# ENVIRONMENTAL REVIEW TEAM REPORT

## PROPOSED WOODS HILL AND CONTON DRIVE SUBDIVISIONS MIDDLEBURY, CONNECTICUT

SEPTEMBER, 1978

# FIGURE 2 VEGETATION MAP

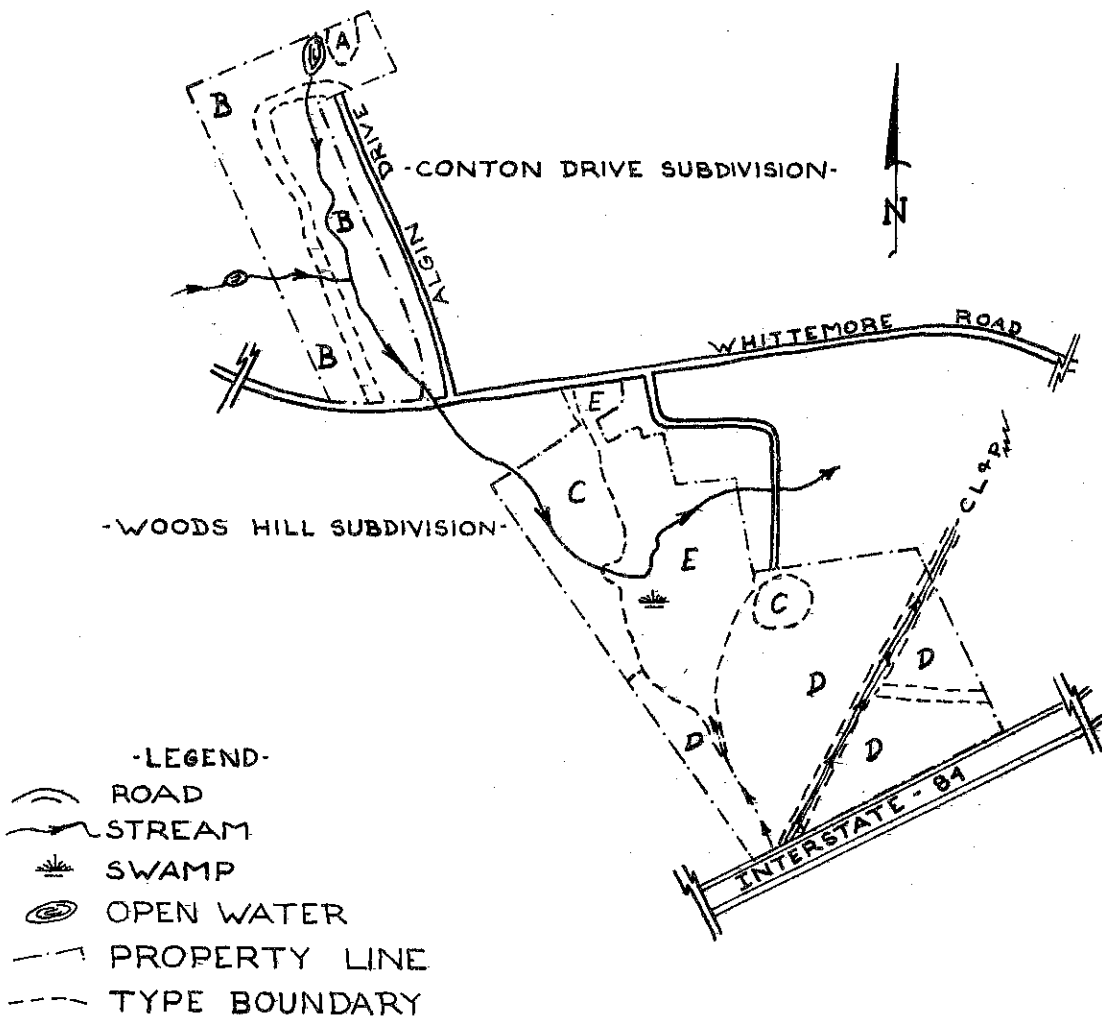
TYPE A - Oak-hemlock, 60-80 years old, 1 acre. This small patch of large conifers provides deep, cool shade and aesthetic variety. This stand is sensitive to disturbance and should be left intact.

TYPE B - Transition hardwoods, 60-80 years old, 30 acres. White oak and black birch predominate. Tulip tree, red and black oak, red and sugar maple, ash, hickory, and yellow birch are common. Witch hazel, spice-bush, barberry, and tree seedlings fill the shrub layer. Various ferns and spring wildflowers also thrive in the rich site. If development occurs, the largest trees should be retained for shade. The intermediate trees adjacent to openings will provide much less shade, and may blow over or die of sudden exposure. These intermediates should be removed and sold as firewood.

TYPE D - Red maple, oaks, and hickory, 40-60 years old, 16 acres. Witch hazel, high-bush blueberries, and red maple seedlings are common. Ground level vegetation varies from ferns, where moisture is available, to club moss and Canada mayflower on the steeper, south facing slope. As in Type B, the trees with spreading crowns should be favored and the narrow-crowned intermediate trees adjacent to new openings should be cut and sold as fuel wood. Large trees which must be removed are merchantable as small sawlogs.

TYPE E - Red maple swamp, 40-60 years old, 15 acres. In the shade of the red maple canopy are ferns and spicebush. Small clearings (the wettest sites) contain phragmites, touch-me-not, and wild rose. Raising the water table may kill the red maple and cause development of an open marsh with standing dead trees. The site performs an important role in removing suspended silt particles from the un-named tributary of Hop Brook.

TYPE F - Right of ways, 9 acres. These vary from sedges and grasses to upland shrubs and tree sprouts, depending on available moisture. The CL&P right of way has probably been maintained by herbicide applications. Residue levels in soil and water should be checked prior to development.

**FIGURE 4  
WATERSHED MAP**

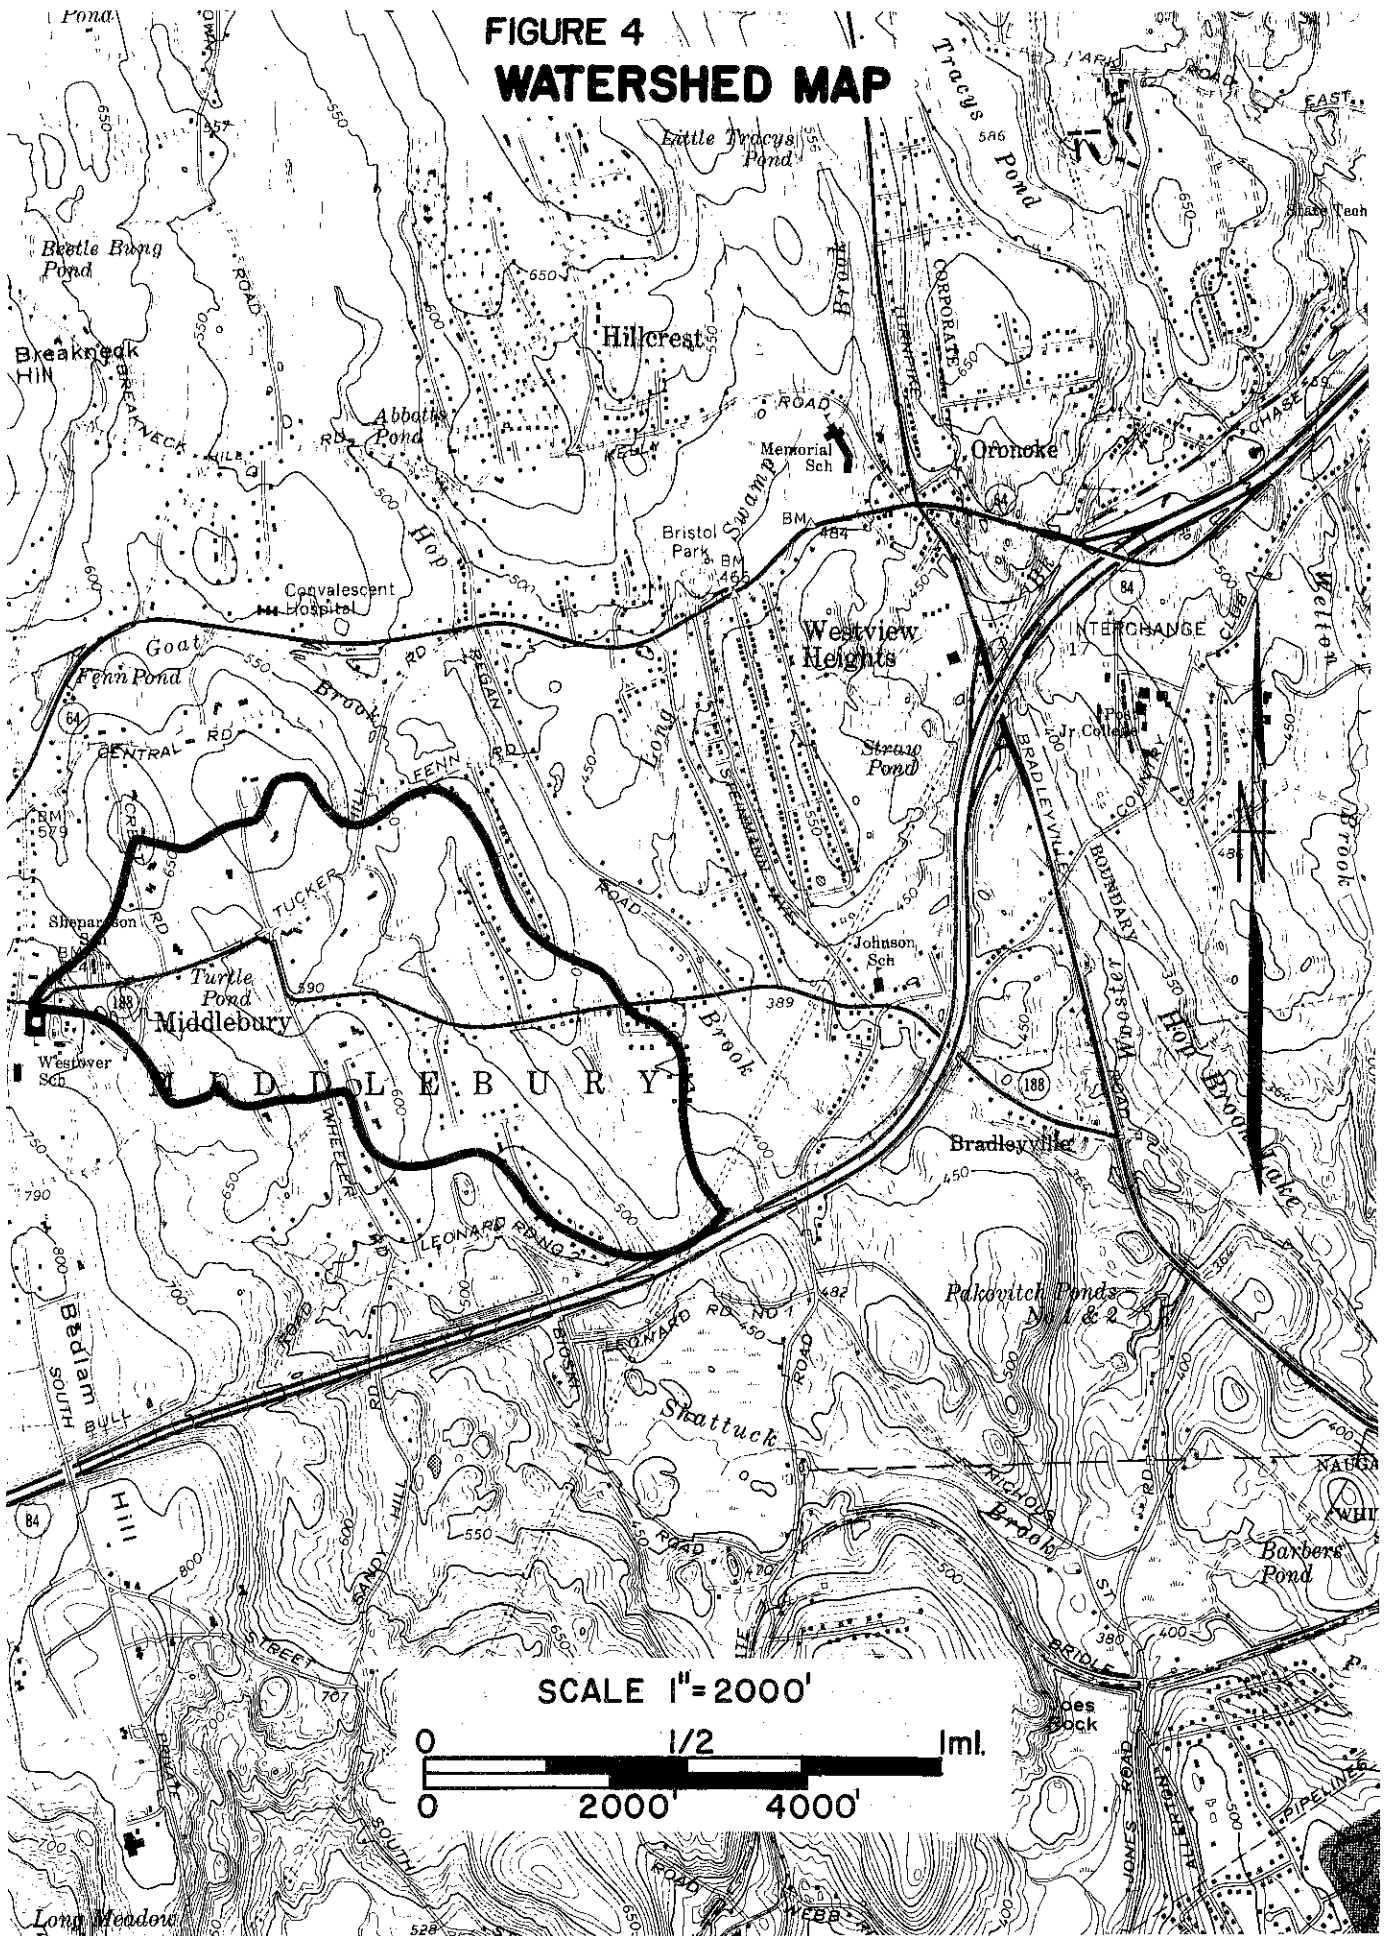
The entire Conton Drive parcel and part of the Woods Hill parcel contribute run-off to a small brook that passes through a culvert under Tower Road and ultimately joins Hop Brook. The total watershed area that drains through the culvert is shown in Figure 4; the amount of land involved is approximately 406 acres. Run-off from the remainder of the Woods Hill parcel flows into a wetland that is located east-southeast of Tower Road. This wetland normally drains through a culvert near a pumping station on Shaddock Road. Near the station, the small stream that emerges from the wetland is separated from Hop Brook's main channel by a gravel-and-fill ridge up to 5 feet high. Because of heavy vegetative cover, the ridge could not be followed to its end on foot; however, aerial photos of the wetland suggest that the ridge may be continuous with an irregular sand-and-gravel deposit that extends eastward from Tower Road about 100 feet north of the cul-de-sac.

Flooding problems have been severe on Tower Road. Three major problems occur during heavy precipitation and/or snow-melt: 1) water overtops the culvert on Tower Road; 2) water from a wetland located west-southwest of Tower Road discharges across a local-resident's property into the cul-de-sac, and from there flows northward along the road toward the brook; 3) water in the wetland located east-southeast of Tower Road rises to a level of near-encroachment on the lawns of some residents living on the east side of the road. All three problems should be fully addressed before further development on Tower Road proceeds. Some initial considerations of each problem are given below.

With problem 1, the crucial point seems to be not so much the amount of run-off that development of the two subdivisions would add to peak flows at the Tower Road culvert, but the advisability of placing more homes along an extended Tower Road before the flooding situation is proved to be corrected. The amount of land that would be developed within the watershed of the Tower Road culvert would be approximately 18 acres, or 4.4 percent of the total area. It is unlikely that this limited amount of development would add more than 1 or 2 percent to peak flows at the culvert. The Conton Drive subdivision alone would have a negligible effect, The Woods Hill subdivision should cause only a small increase as well, but this proposal differs in that it would place an additional 18 homes along a road on which serious flooding is already a problem. If access to these homes is cut off because of flooding on Tower Road, along with the inconvenience to residents, grave consequences could result if police and fire vehicles and ambulances cannot get through. Hence, before development of Woods Hill proceeds, it would seem imperative that the watershed of the Tower Road culvert, as it would exist following development, be completely

analyzed and peak flows following major storm events (such as the 50-year or 100-year storm) determined. The culvert should then be improved enough to handle these peak flows. Such detailed engineering determinations are outside the scope of the ERT.

# SOILS MAP

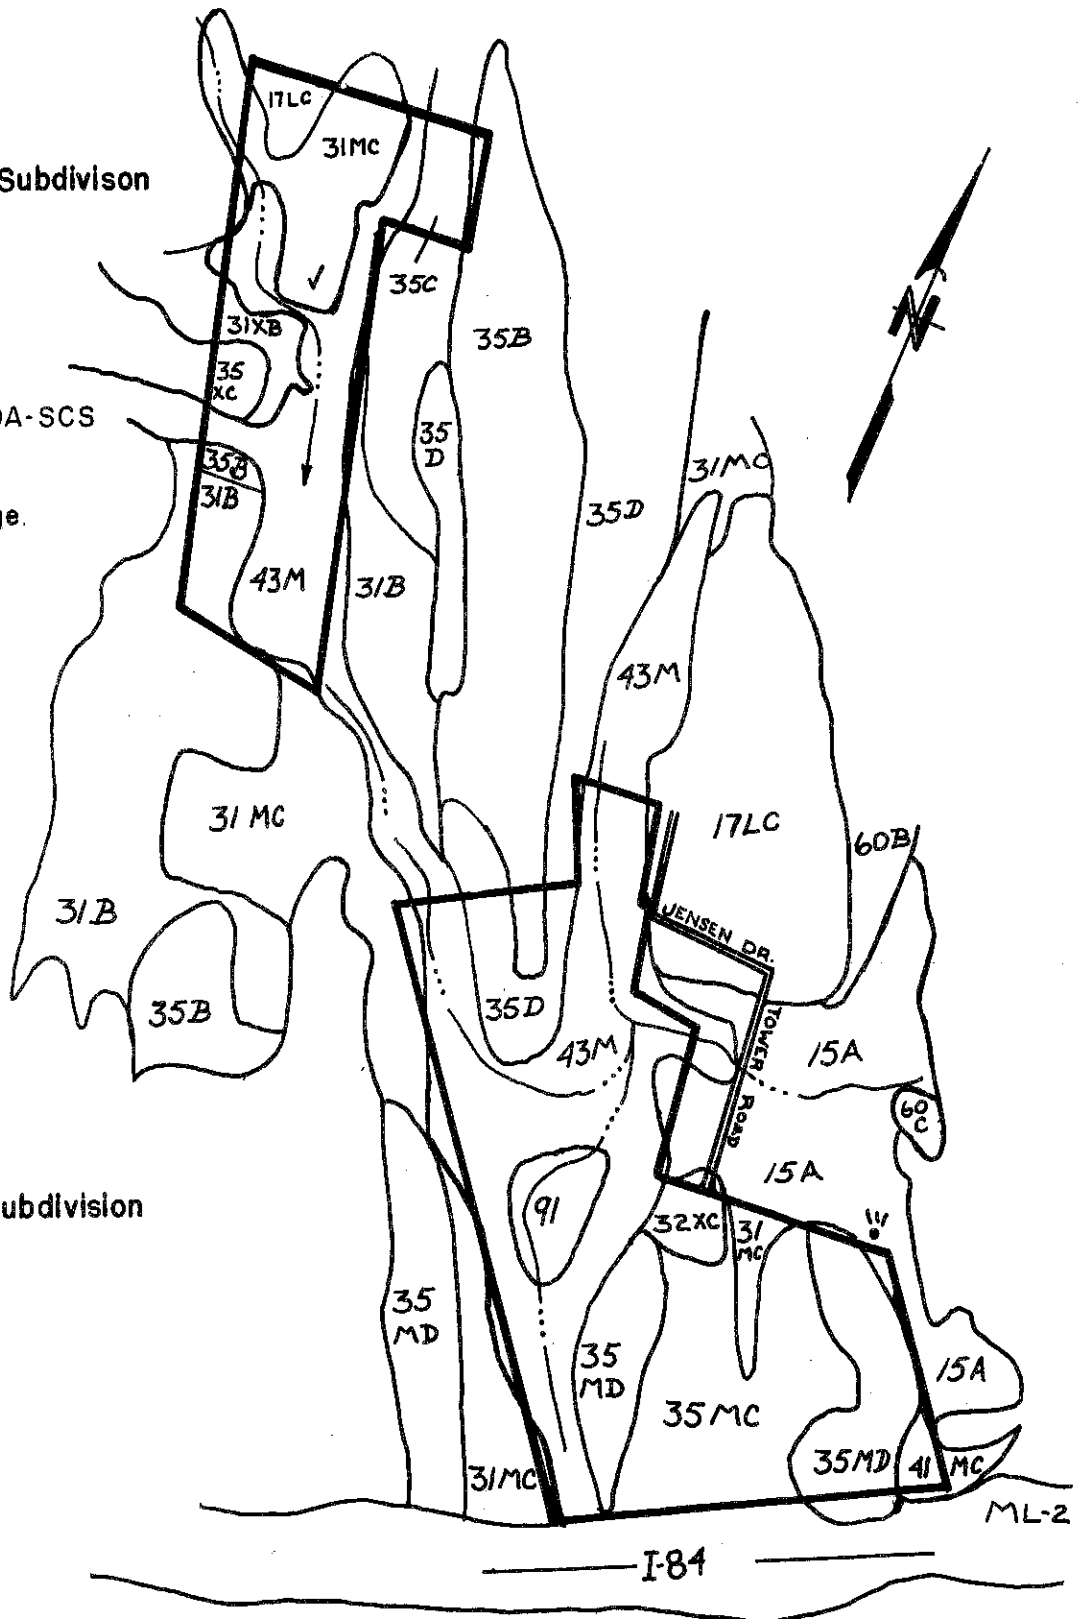
As can be seen from studying the soils map and soils limitation chart, much of the Conton Drive area is characterized by wet soils.

Over one-third of the property is underlain by soil type 43M (Ridgebury, Leicester, and Whitman extremely stony soils). These soils are very poorly drained and have water ponded on the surface for significant periods in winter and spring. The water table usually remains within 3 feet of the surface throughout the year. These soils have severe limitations for urban and most other uses. Intensive and costly drainage and land fill measures are required to overcome wetness. In addition, the stones and boulders common in these soils will add difficulty to earth moving operations. These soils are regulated by the Connecticut Inland Wetlands and Water Course Act.

The other major soil type on the property is Woodbridge (31B, 31XB, 31MC). These soils are underlain by compact glacial till and have a hardpan 16 to 36 inches below the soil surface. Permeability above the hardpan is moderate but the pan drastically reduces percolation. These soils also have a high water table during wet seasons. During the period of highest

Paxton soils (35B, 35MD, 35MC, 35D) make up the majority of land proposed for development at the Woods Hill Subdivision (see Soils Map). These are well-drained upland soils formed over compact till. Paxton soils on this property consist of the following types:

The other two major soil types on the property, 43M and 91, are both inland wetland soils. Due to the very severe limitations of these soils for urban uses and their hydrological importance (wetlands serve to moderate the effects of run-off, filter nutrients, and trap sediment), the developer's decision to leave these areas in their natural state is a judicious one.
